NOAA FORM 76-35A	
U.S. DEPARTMENT OF COMMERCE NATIONAL OCEANIC AND ATMOSPHERIC ADMINISTRATION NATIONAL OCEAN SERVICE	
DESCRIPTIVE REPORT	
Type of Survey .....	Field Examination
Field No. ....	
Registry No. ....	F00064
LOCALITY	
State .....	Washington
General Locality .....	Puget Sound
Sublocality .....	Shilshole Bay
.....	
<u>1948</u>	
CHIEF OF PARTY	
.....	
LIBRARY & ARCHIVES	
DATE .....

SHILSHOLE BAY, PUGET SOUND, WASHINGTON

REVIEW OF F.E. NO. 1 (1948)

FE 1 (1948)  
 Surveyed in 1948  
 Soundings, in feet at MLLW  
 Scale 1:10,000

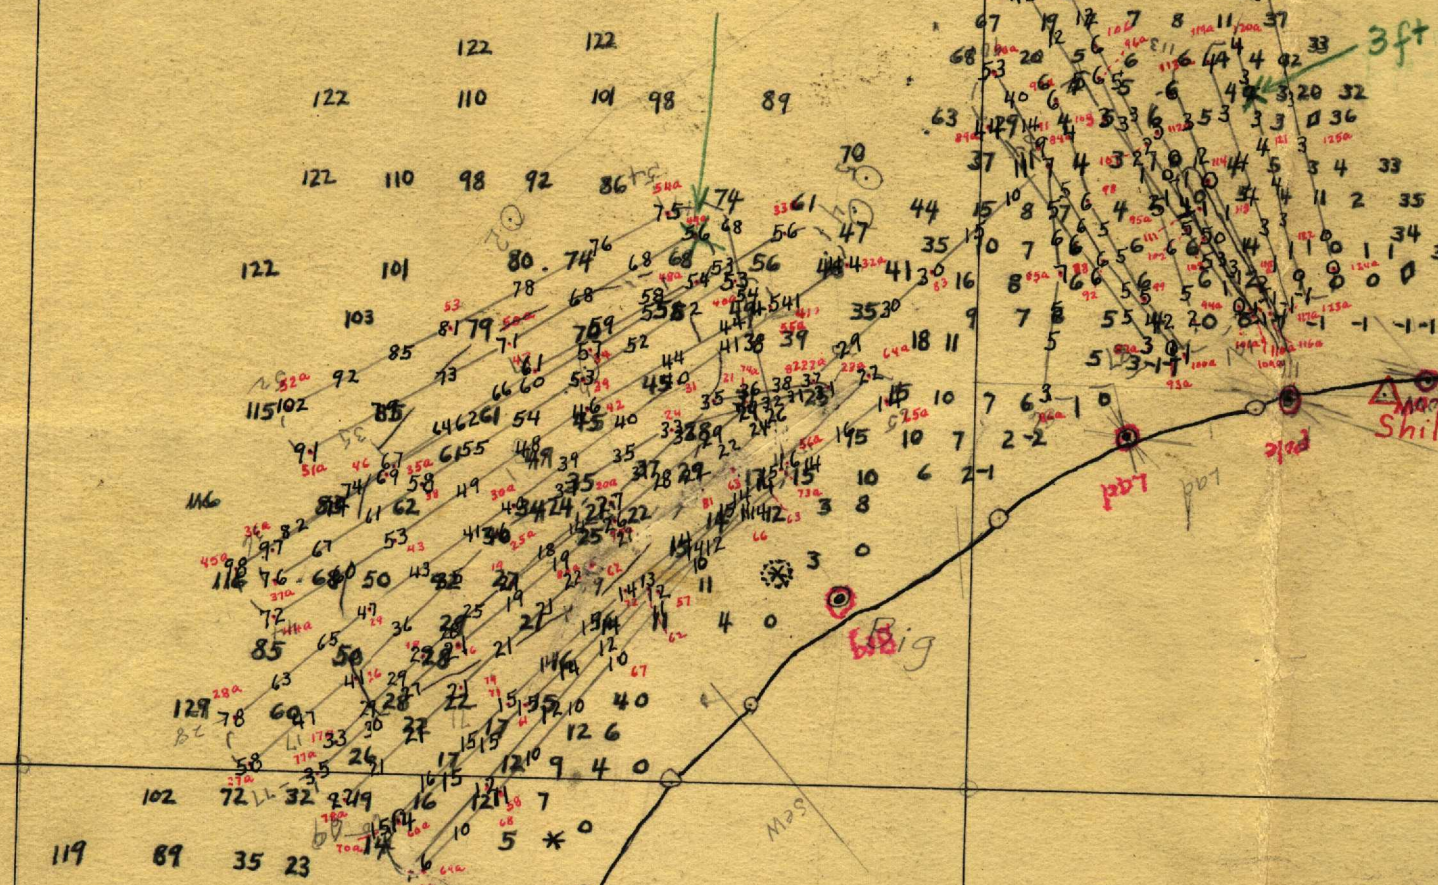
The present hydrography, together with soundings transferred from H-5724 (1935), are plotted on the attached boat sheet. A tracing of the boat sheet showing only the soundings of the present examination is also included. Numerous soundings were traced erroneously and have been corrected. The soundings were reduced from predicted tides.

- (1) The uncharted 14-ft. sounding at the sewer outfall in lat.  $47^{\circ} 40.19'$ , long.  $122^{\circ} 25.42'$ , was omitted on the tracing. The sounding was partially obscured by other soundings on the boat sheet. *off limit of Chart 6447*
- (2) The charted 14-ft. sounding in lat.  $47^{\circ} 40.46'$ , long.  $122^{\circ} 25.00'$ , was erroneously traced from a 44-ft. sounding on the boat sheet. ✓

The examination reveals that a sand bar now projects out from the foreshore and supersedes in part the 4-to 6-ft. depths on H-5724 (1935). Also the 14-ft. sounding in item (1) above supersedes a detached 21-ft. sounding at the sewer outfall. No other changes in depth in the vicinity of the outfall were noted in a comparison with H-5724. The 51-ft. sounding in prior and present depths of 68-ft. in lat.  $47^{\circ} 40.39'$ , long.  $122^{\circ} 25.30'$ , may be an obstruction or a stray recording; however, the fathogram shows no other similar traces which would indicate stray recordings on this fathogram.
